APPLICATION FOR APPROVAL TO USE AN EXISTING ON-SITE WASTEWATER TREATMENT & DISPOSAL SYSTEM / WATER SUPPLY WELL

Project #457299

Home addition

4837 LAKEVIEW RD,
CHARLOTTE NC 28216

1 / B3.0 WALL SECTION DETAIL@BRICK PIER
SCALE: 1" = 1'-0" AT DINNING RM

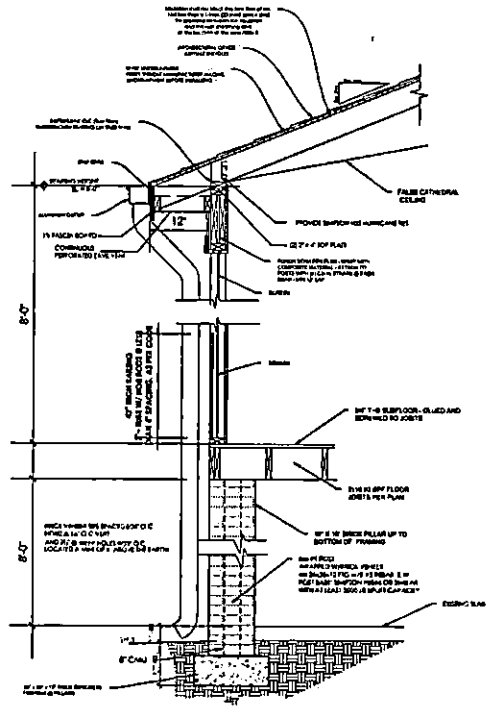
Approved as Noted per Following:
-Verify encapsulation of insulation per N1102 in the 2018 NCRC under floor joists
